PROJECT TITLE: Los Diamantes Subdivision ZONE MAP/DRG. FILE: **N09 / D013**

Los Diamantes Subdivision
Drainage Management Plan

**RE: Los Diamantes Subdivision
Drainage Report, and Grading and Drainage Plan
Engineer's Stamp Date 1-13-2015 (File: N09D013)**

**Re: Los Diamantes Subdivision
Revised Engineers stamp date 3-24-15 (N09 / D013)**

LOS DIAMANTES SUBDIVISION STREET CAPACITY EXHIBIT

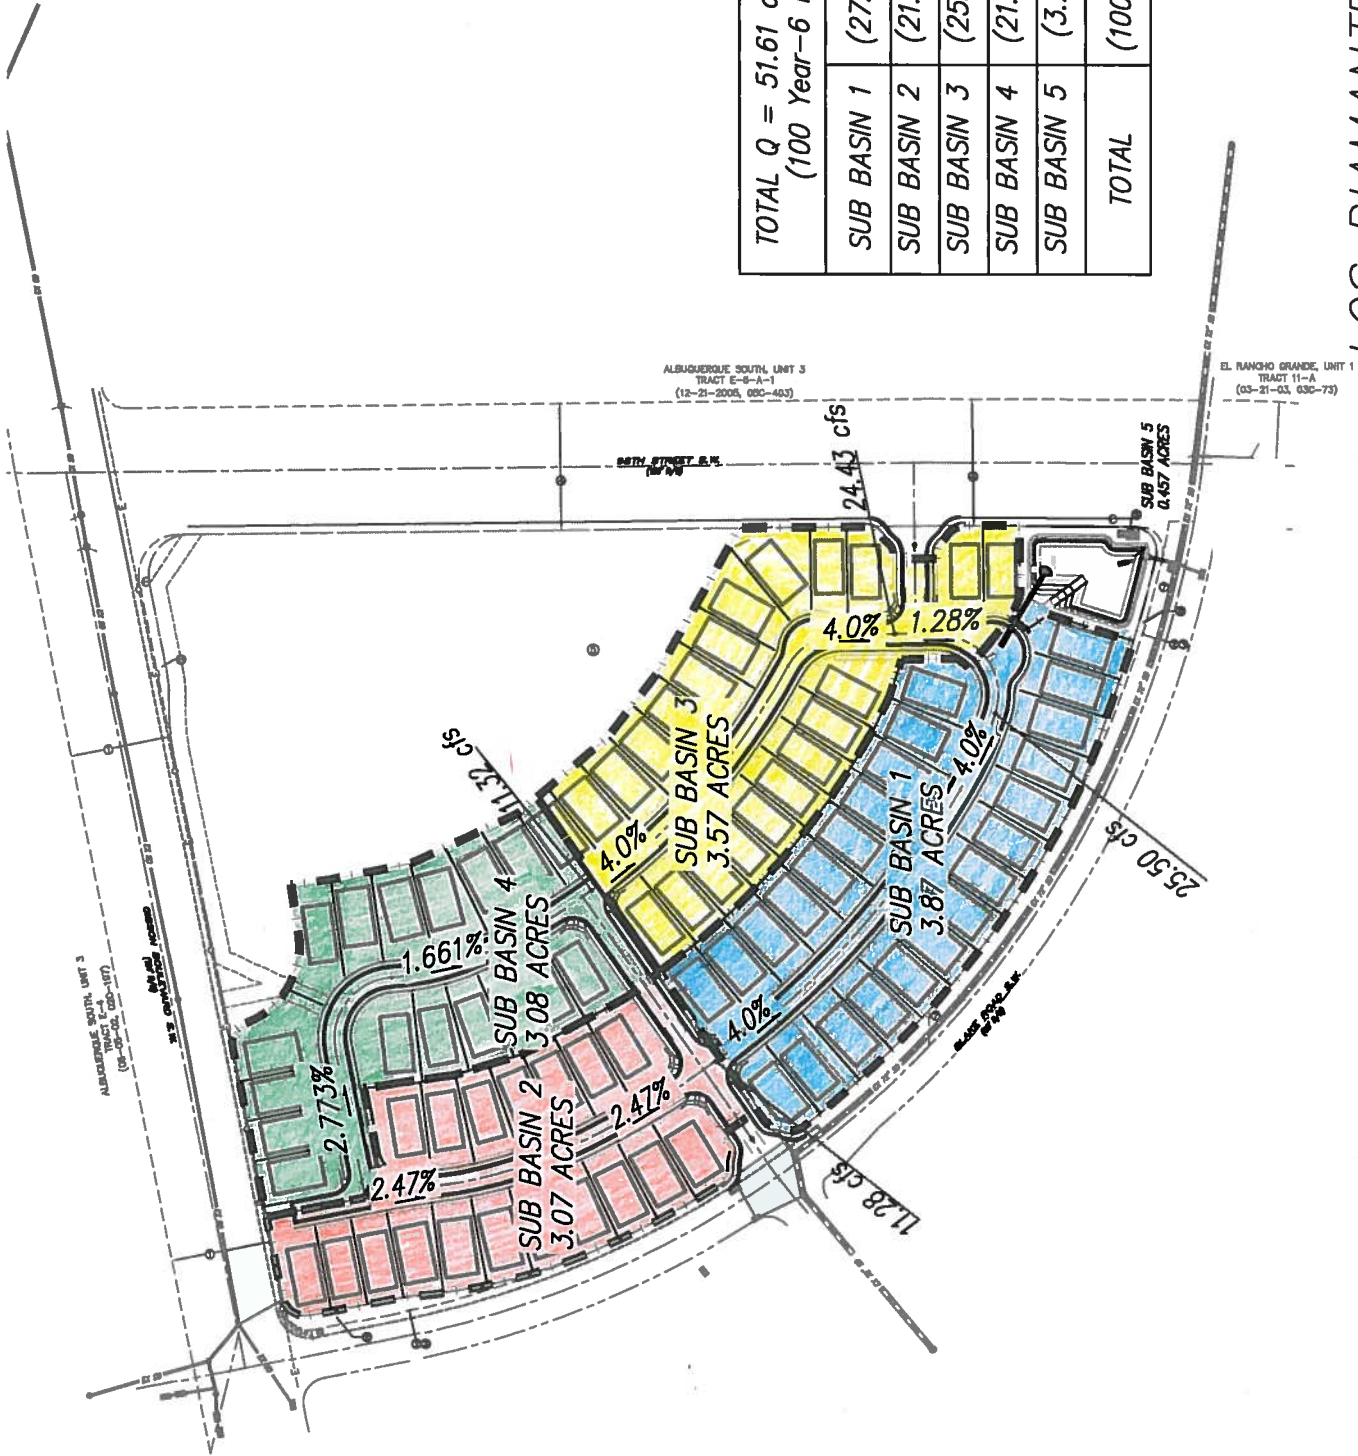
8. How will flows discharge into the pond?
9. Provide Basin Boundary map showing peak flow rate from each basin.
10. Provide Street capacity calculations. On Basin map show the max. peak flows for both the mountable curb sections and the standard curb sections.

9. There is only one basin for this site. Refer to the street capacity exhibit in appendix C for a sub basin boundaries as they relate to street capacity calculations

OUTFALL TO BLAKE ROAD STORM DRAIN

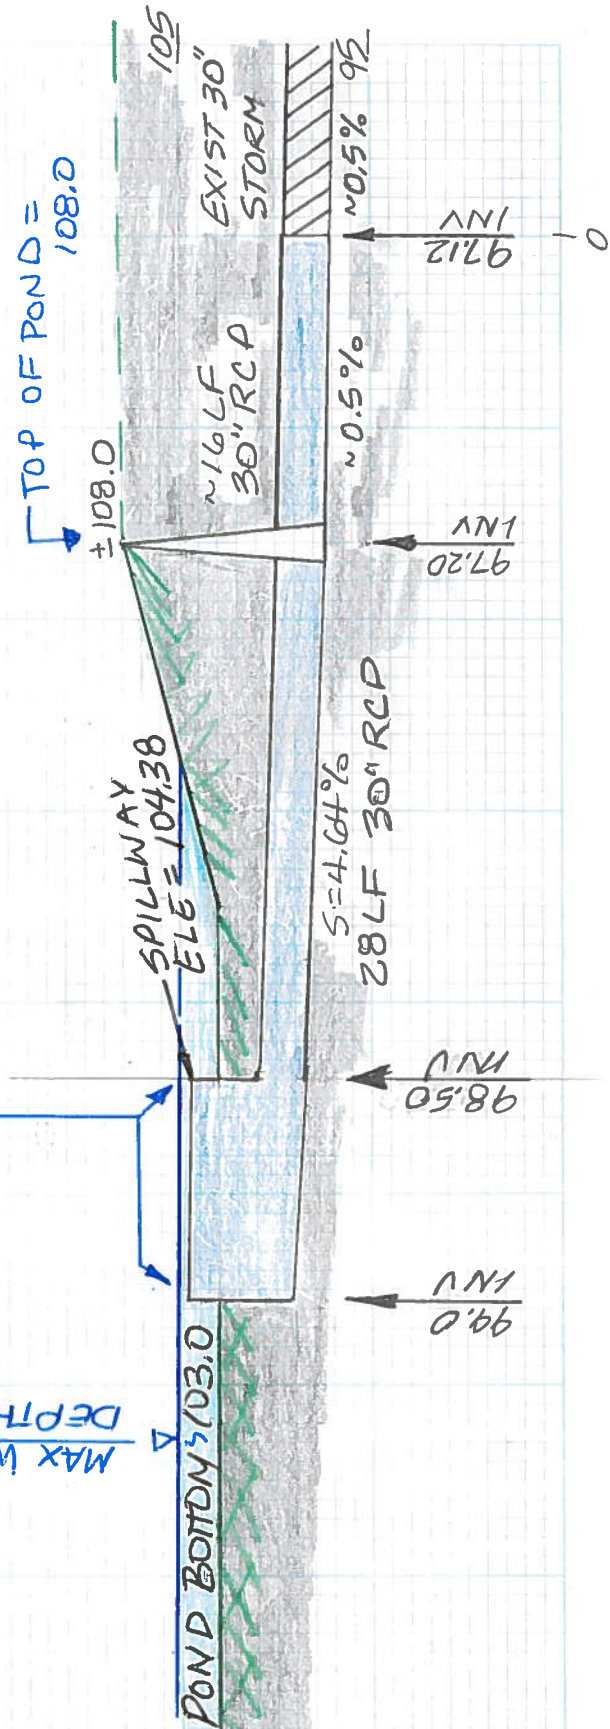
4. What is the meaning of the hatched line within the pond? It is not on the legend, but appears to be some sort of wall.
5. The outfall structure is 8.5' in diameter that discharges to a 30" SD. For safety reasons, it is preferred to provide a stand pipe/riser, with the top open for emergency overflow.

4. This hatching has been eliminated on the revised plan.
5. The configuration of the outfall has been change to 3' wide by 10.5' long rectangular box outfall. There will be bars placed on top of the structure for safety.

OUTFALL STRUCTURE = 10.5' x 3.0' OPENING
AT SPILLWAY ELE = 104.38
(A GRATED COVER TO BE
DESIGNED AT DRC TO
KEEP KIDS OUT)

Basin Boundary -
Sun Gate Estates
EXHIBIT 4

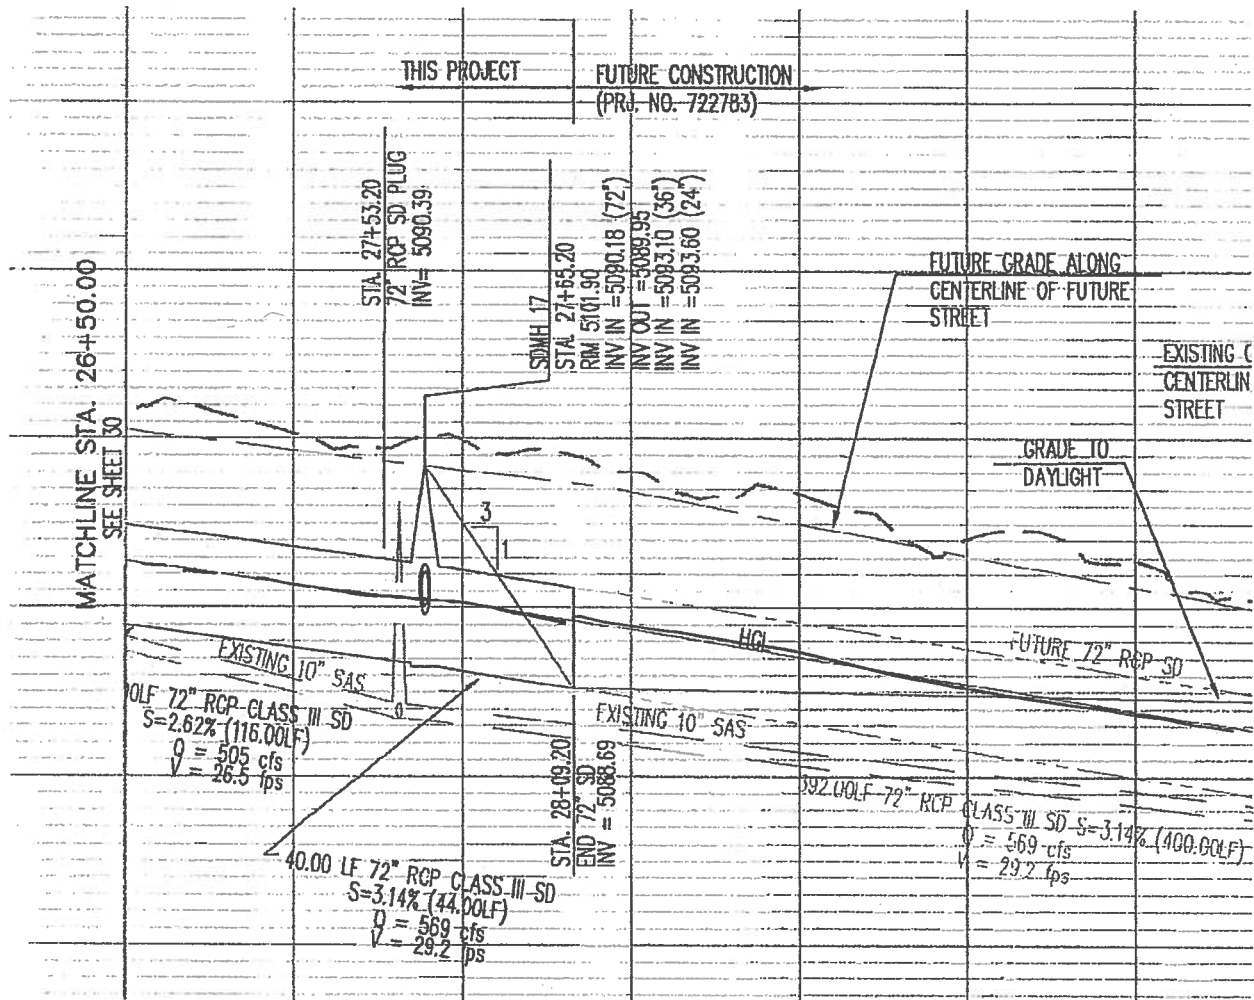
11. The referenced Amole-Hubbell report was never approved by the City. It's primary purpose was to evaluate AMAFCA's facilities, but not the storm drain systems. While it provides guidance, further investigation is required to verify the allowed discharge into the 72" Storm Drain in Blake Road.

12. Along that same note, what basins was the 72" Storm Drain in Blake road designed to support? Did it follow the Amole-Hubbell? Have there been any changes to the flow rate or design assumptions since its original design? Provide excerpts from this report to verify its present capacity.

10. OK.
11. At our meeting last week, it was decided to use the as built storm drain from the Sun Gate Estates Phase I Utility Plan (CPN:736782, approved 3-4-05) and the Sun Gate Estates Exhibit 4

Drainage Basin Map (N09/D007) as the guide for calculating the allowable discharge from this project site. At the meeting it was agreed upon that a 50 cfs discharge was acceptable from this project site into the existing 30" storm drain stub located in Blake Road. A pond will be used at the SE corner of the site to retain the first flush and then allow the remaining runoff to discharge into the existing 30" storm drain lateral.

Based on NO9/D007 and as-builts from
 Sun Gate Estates ph 1 736782 we determined
 the down stream capacity to

Look like a pipe storm drain in 98th is required
